7300 TROUVILLE ESPLANADE

DESIGN REVIEW BOARD MEETING
NOVEMBER 2, 2021

Zoning: RM-1
Future Land Use: RM-1

LOT COVERAGE WAIVER

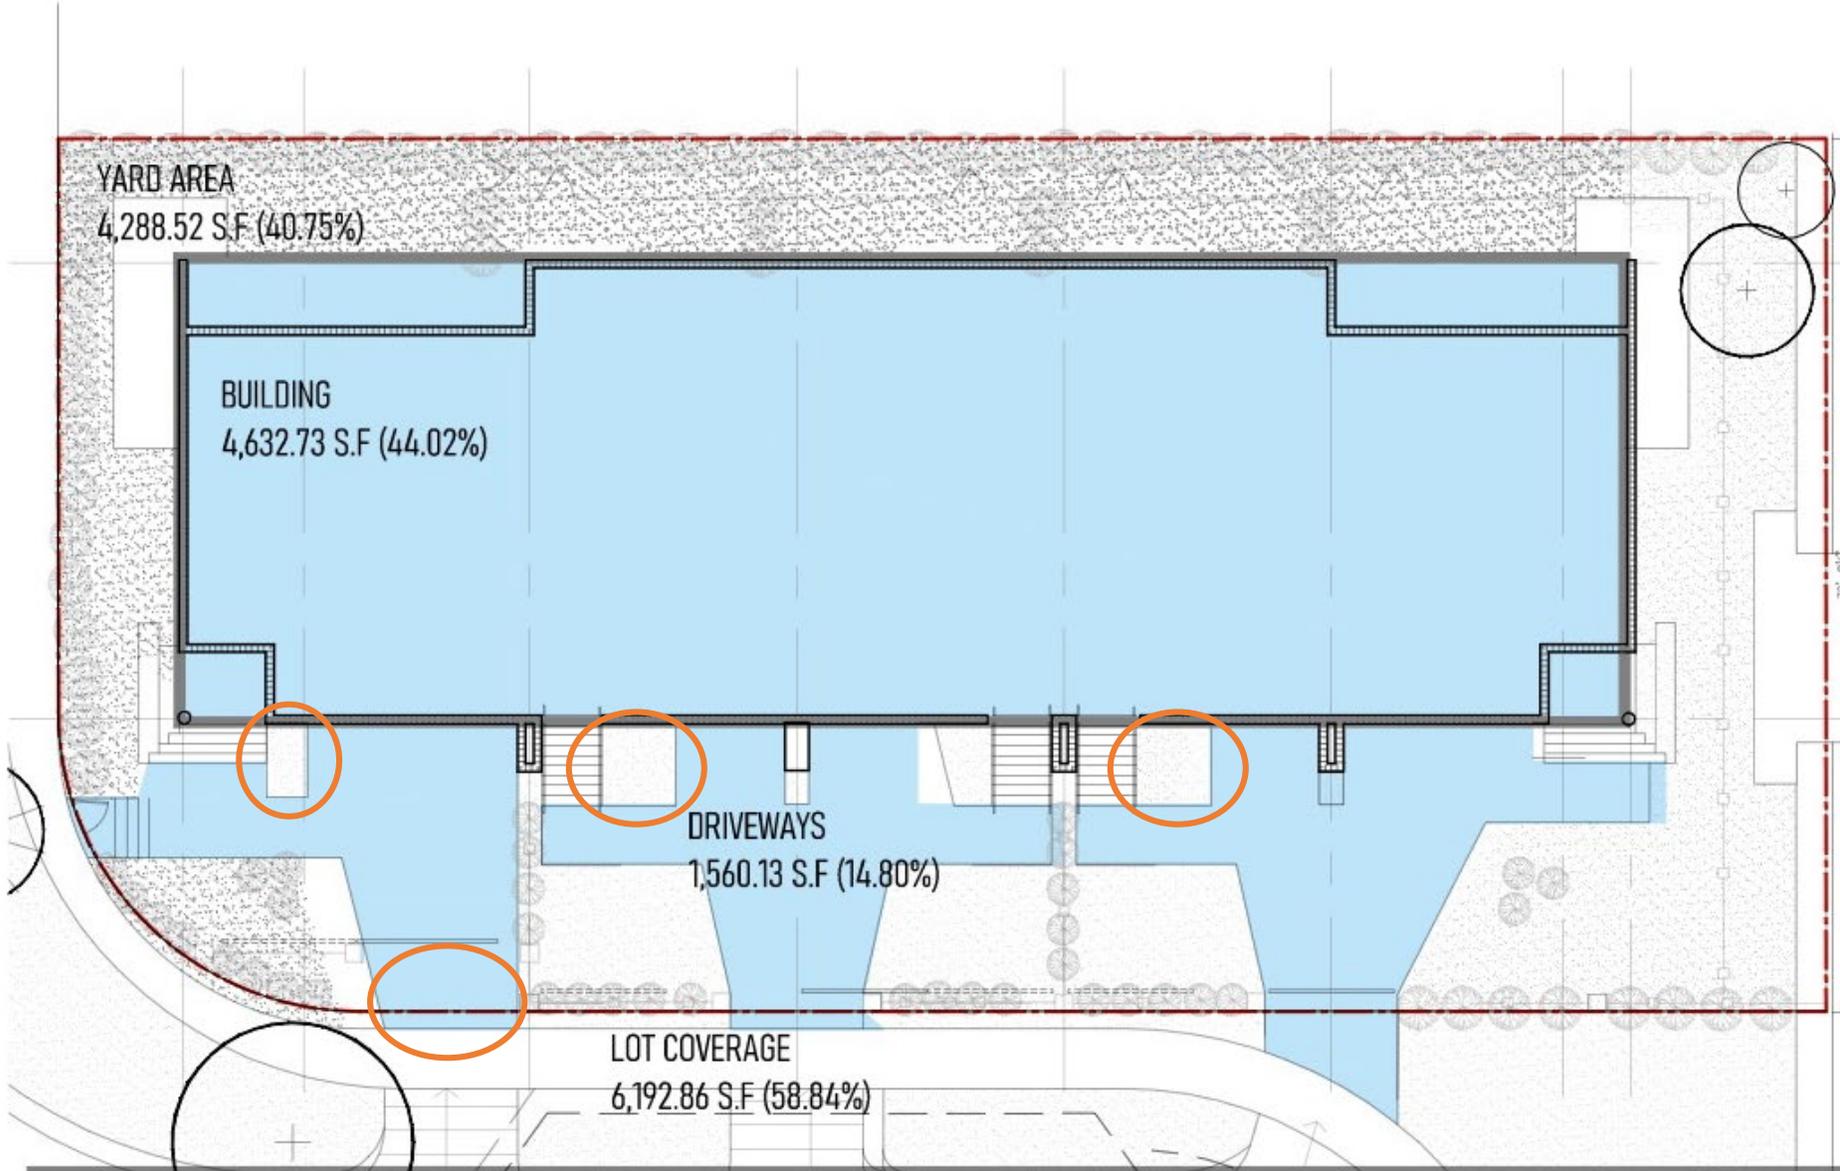
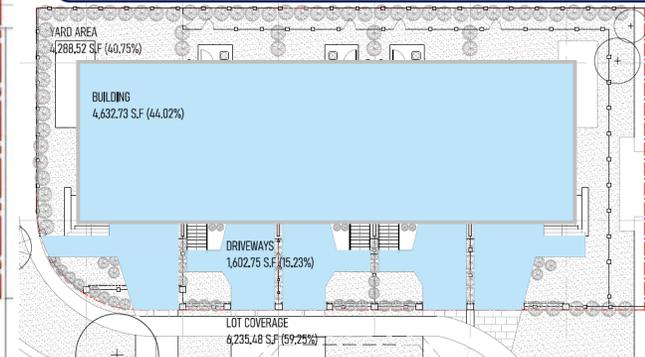
REVISIONS PER STAFF COMMENTS:

- Increased landscaped areas.
- Decreased all driveway widths to 11'-0".
- Overall reduction in Lot Coverage from 59.25% to 58.84%.

GROUND FLOOR PARKING GARAGE WAIVER

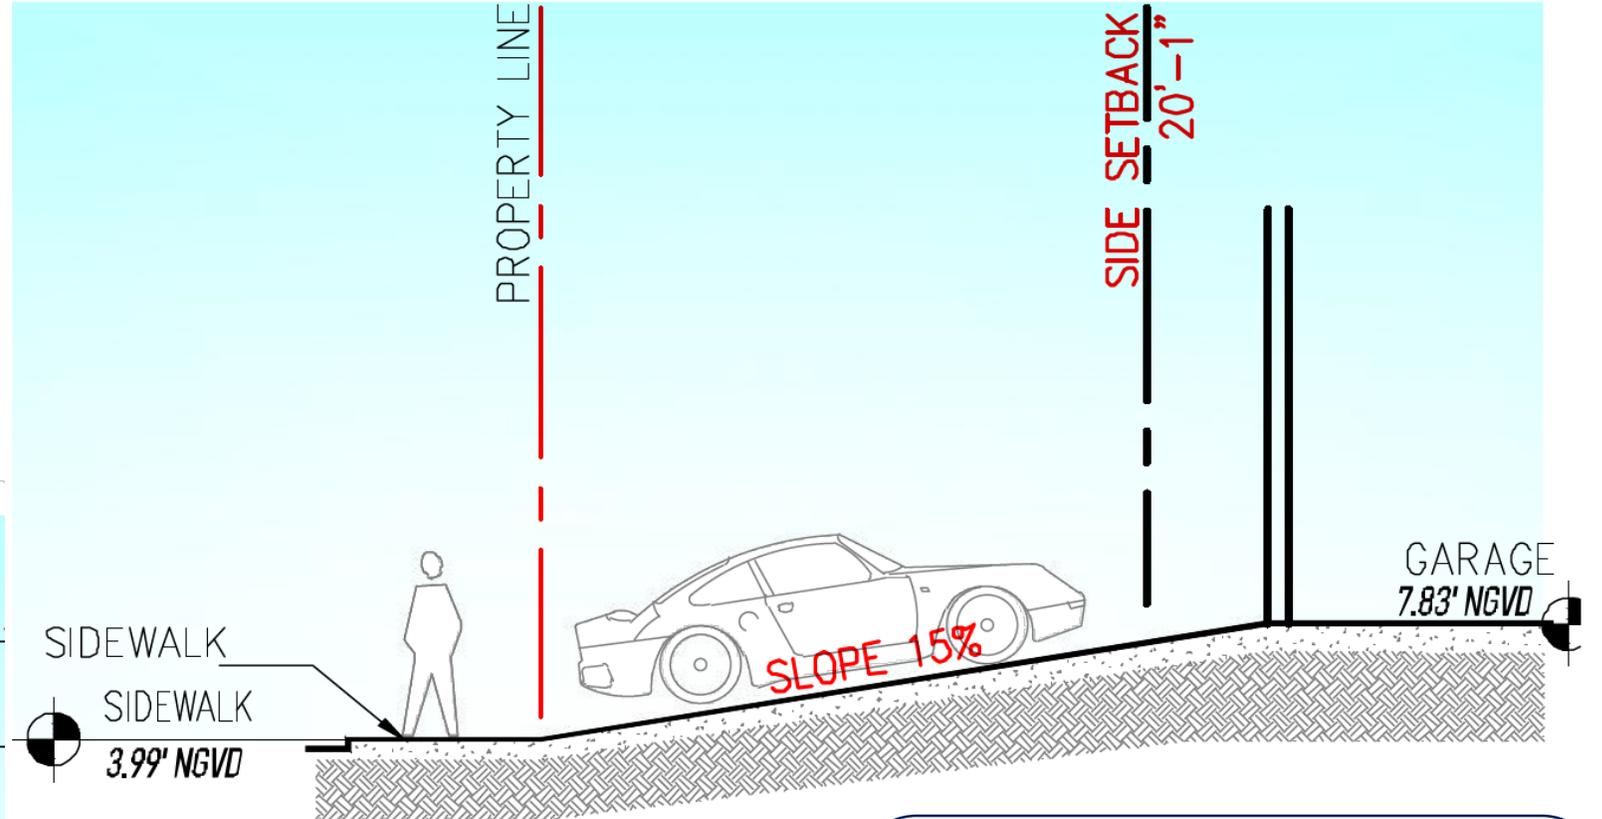
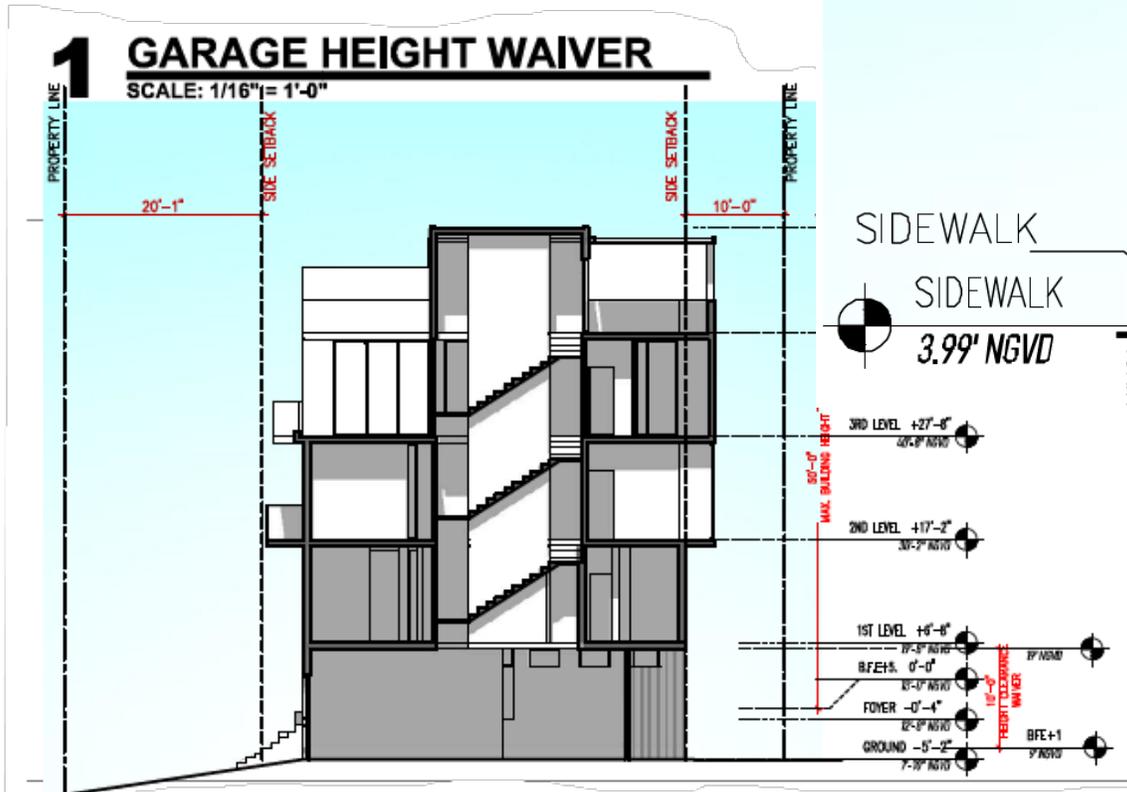
PREVIOUSLY PROPOSED HEIGHT (VARIANCE): 7'-7"

CURRENTLY PROPOSED HEIGHT (WAIVER): 10'-0"

SOUTH ELEVATION

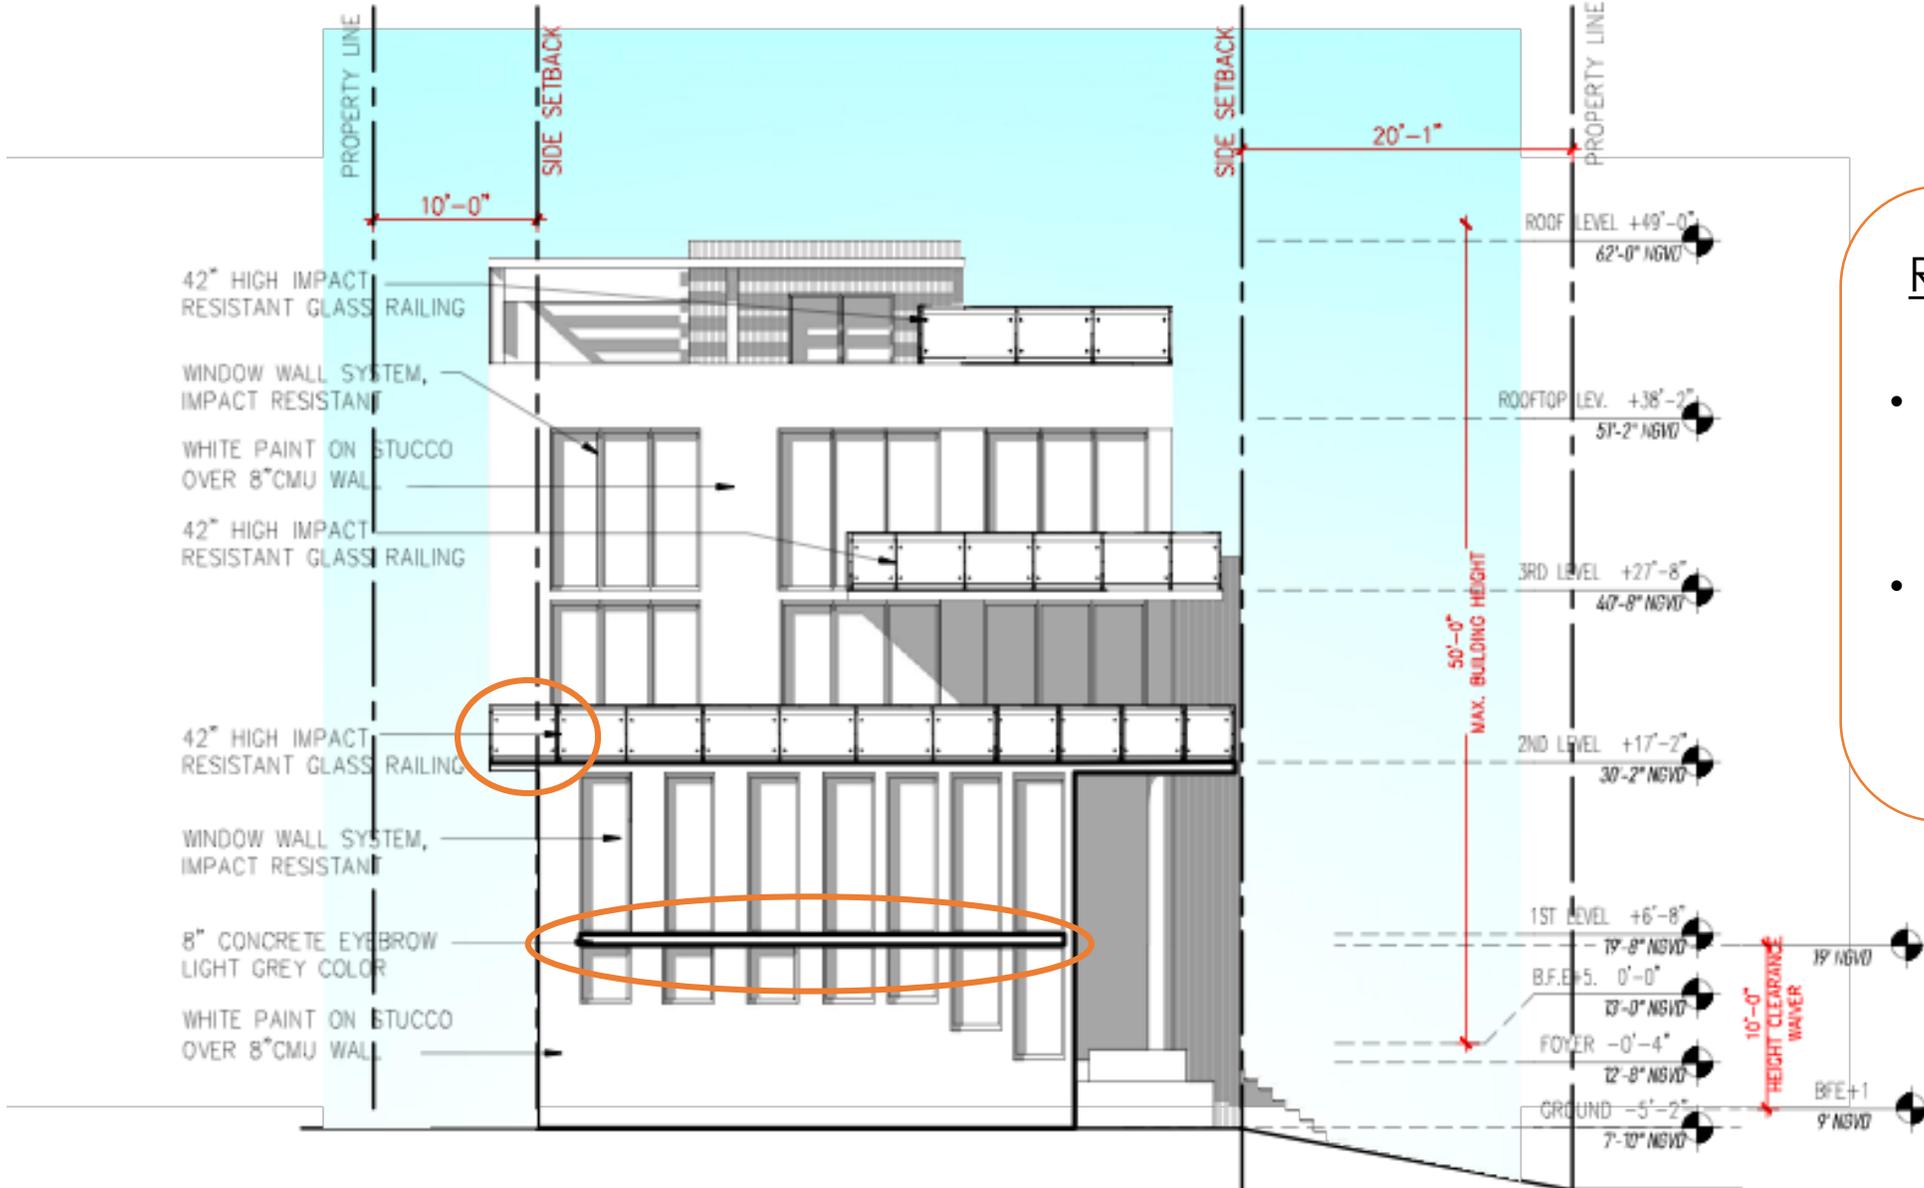
REVISIONS PER STAFF COMMENTS:

- Extended balcony to improve south facade.
- Included eyebrow treatment on ground floor for added symmetry.

NORTH ELEVATION

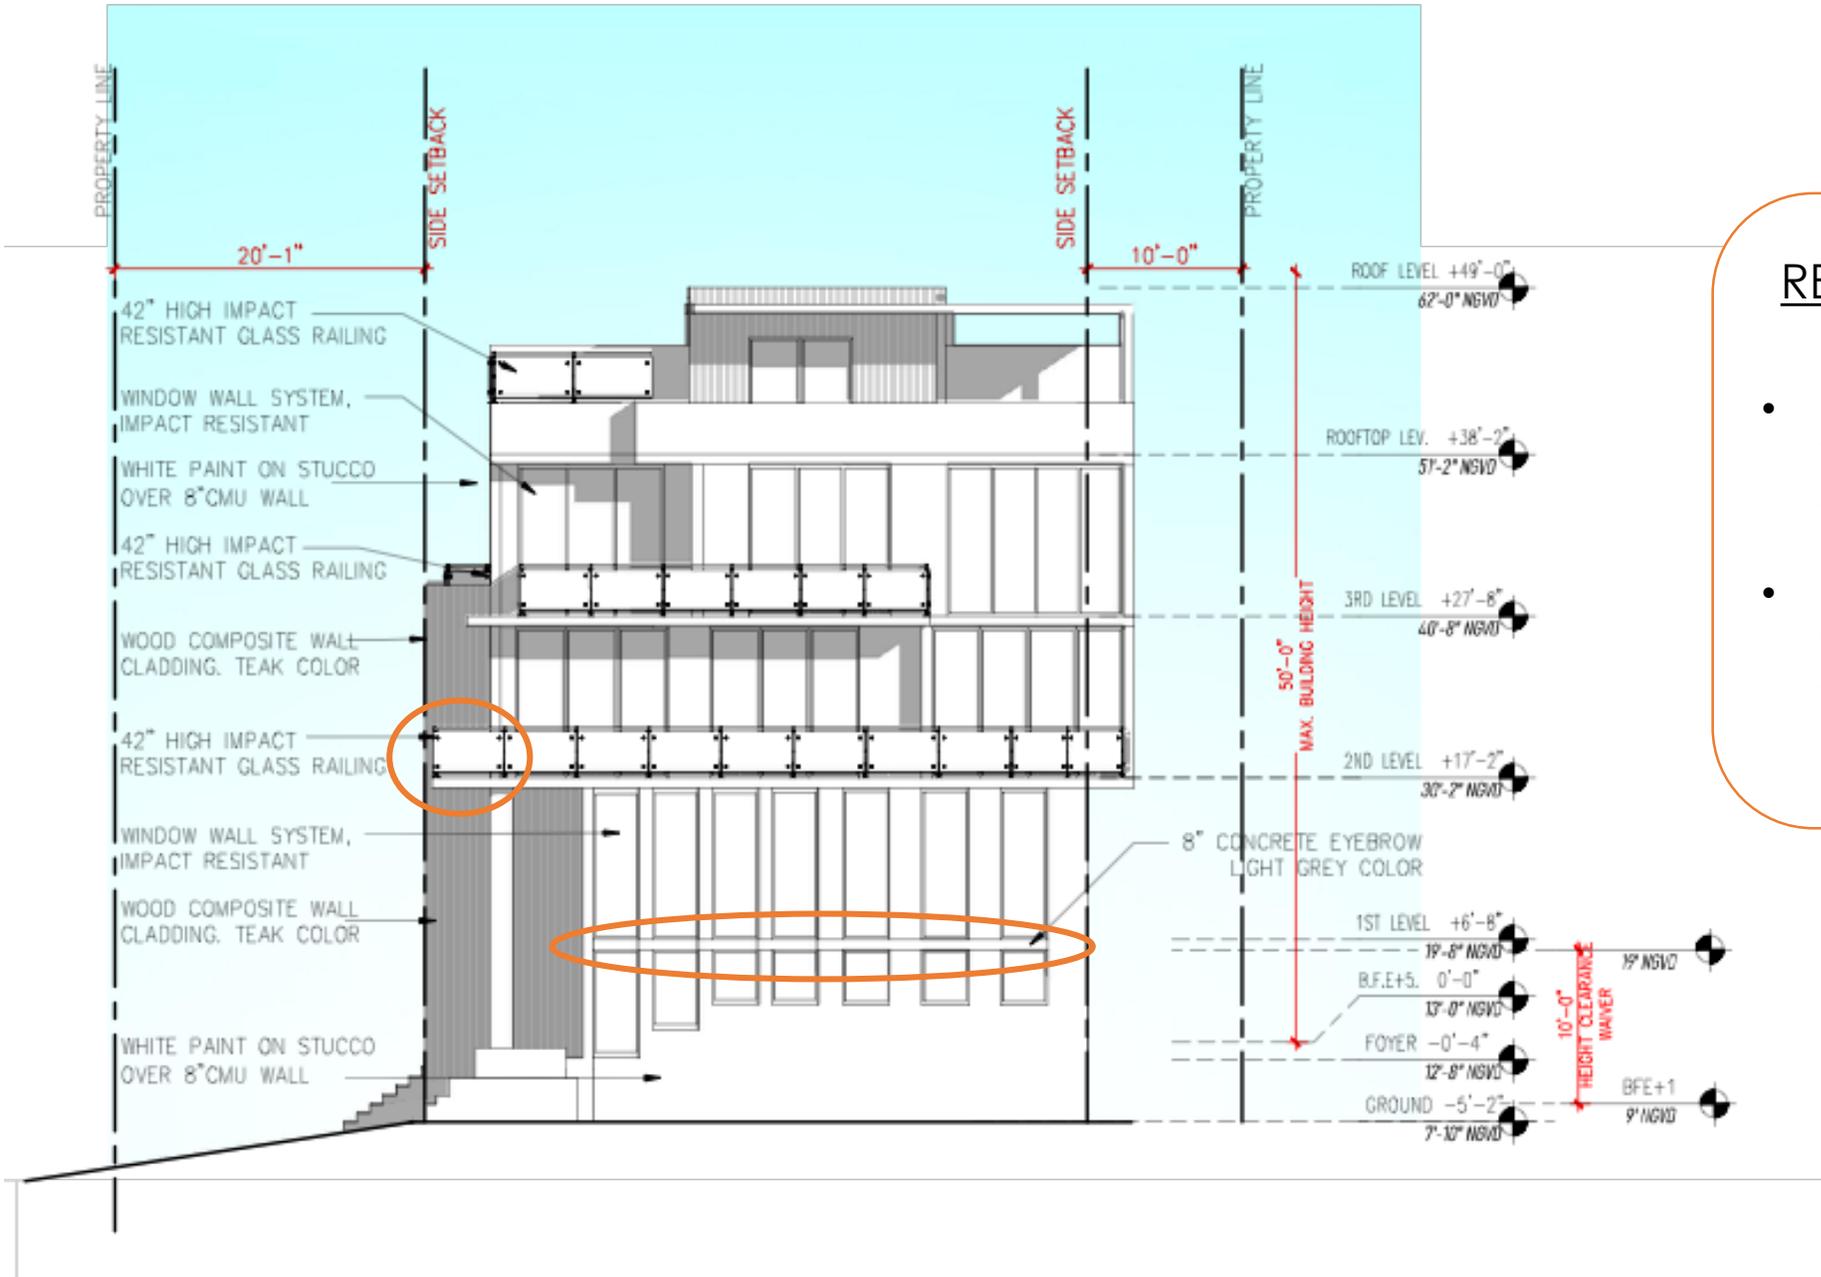
REVISIONS PER STAFF COMMENTS:

- Extended balcony to improve south facade.
- Included eyebrow treatment on ground floor for added symmetry.
